MCPB  
Item No.  
Date: 7.21.16

Project Name: Sligo Artspace,  
Mandatory Referral MR2016031, Preliminary Plan No. 120160270, Site Plan No. 820160140

*Submitted plans showing Impacts to CRZ of Tree 1*

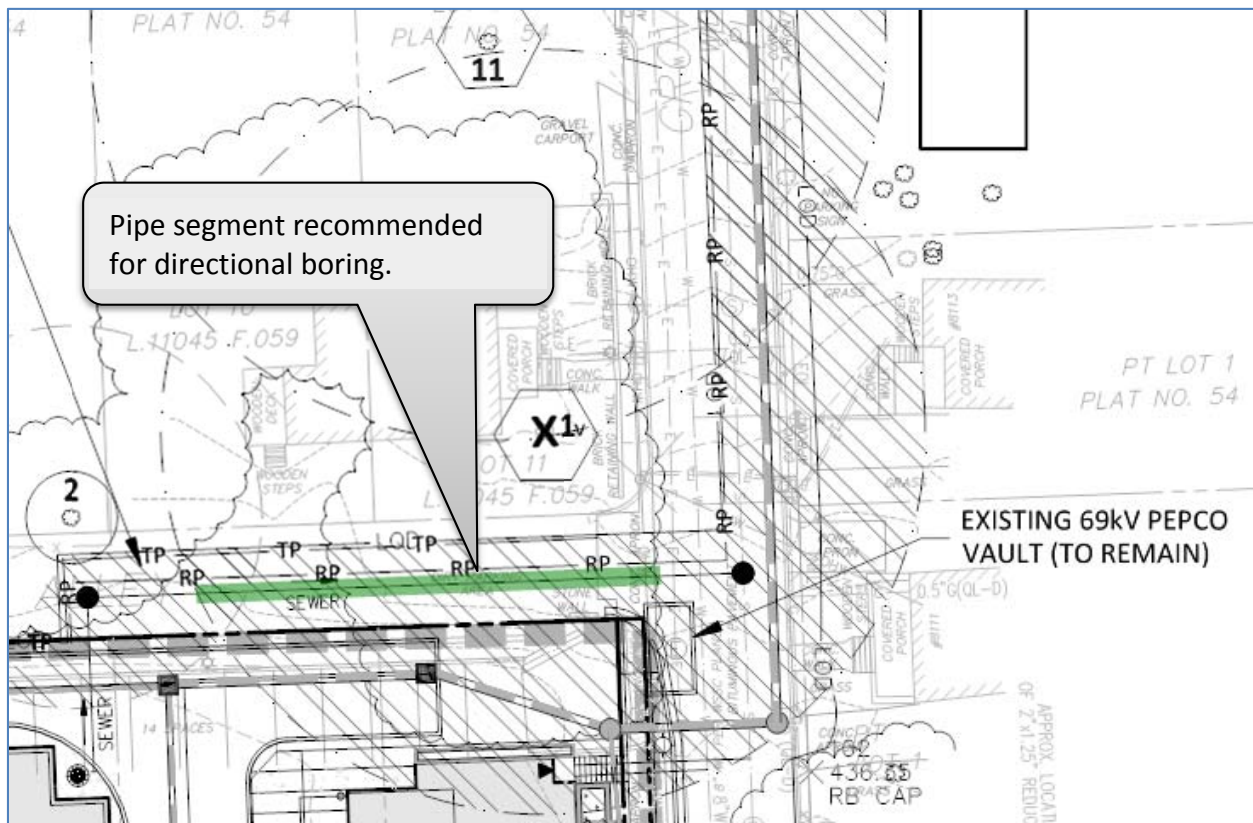
Staff does not support the impacts and resulting potential removal of Tree 1 (illustrated below) relative to proposed activity within the paper street/alley for a sewer line connection, which include traditional trenching for pipe installation that would sever any roots within the excavation. Staff believes that the Applicant has not appropriately explored minimization /avoidance of impacts for this tree. The proposed excavation would likely have a significant impact on the roots of the offsite 48” diameter tree. Even if a number of preservation measures are added, there is potential for the tree to decline from the construction impacts relatively soon (2-5 years) after construction is completed. Additionally, staff notes that older trees are less resilient to impacts than younger trees. The removal of this tree would be among the most difficult (and costly) scenarios for a removal given that the large tree is growing close to the

To avoid the considerable construction impacts as shown on the submitted plans/variance request, Staff recommends as a condition of approval (and partial denial of the variance request) that the sewer line connection within the paper street be directionally bored within the CRZ of Tree 1. The staging and excavation pit(s) for the boring machine which would occur to the west outside of the CRZ of Tree 1 and/or within the Grove Street ROW, east of the existing driveway apron, where few (if any) of the trees roots would be present. The proposed LOD which overlaps the CRZ of Tree 1 within the alley would be removed from the plans.

- b. The sewer line connection within the paper street alley shall be specified as directionally bored within the CRZ of Tree 1. Associated excavation pit(s) shall be located east of the existing concrete driveway apron for the eastern tie-in, and out of the CRZ of tree #1 for the western segment.

*Submitted plans showing Impacts to CRZ of Tree 13*

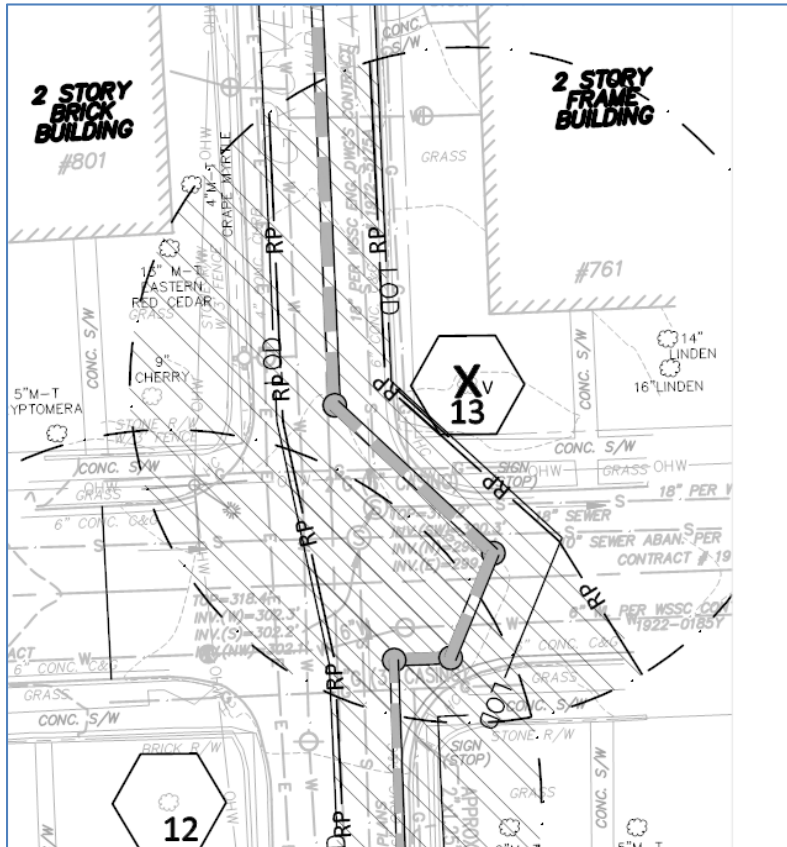
Additionally, staff has concerns with the excessive disturbance shown for offsite Tree 13 (illustrated below). As shown trenching and excavation would be allowed within approximately 8 feet from the base of the tree. The impacts as requested would likely require removal of the tree. The extensive impacts are shown and requested to accommodate potential design changes and a variety of construction methods such as sloping back the excavation face (rather than using temporary shoring that would minimize the disturbance/impact).

Staff notes that there have been relatively minor impacts to the tree from sidewalk reconstruction and other roadway/utility work. However, the impacts currently requested are well beyond any previous impacts to the tree. Staff is recommending as a condition of approval (and partial denial of the variance request) that the impacts for trenching and excavation impacts to Tree 13 relative to the northeast corner of the intersection be limited to no more than a 5-foot offset from the edge of the pipe location that is currently proposed. However, equipment access between the tree and 5-foot offset would be allowed if the area is appropriately armored with temporary root protection matting.

- c. Reduce disturbance near Tree 13 to the greatest extent possible, however any trenching and/or excavation shall be no closer than 5 feet offset from the location of the pipe as currently proposed. Equipment access between the tree and 5-foot offset may occur if the area is appropriately armored with temporary root protection matting.
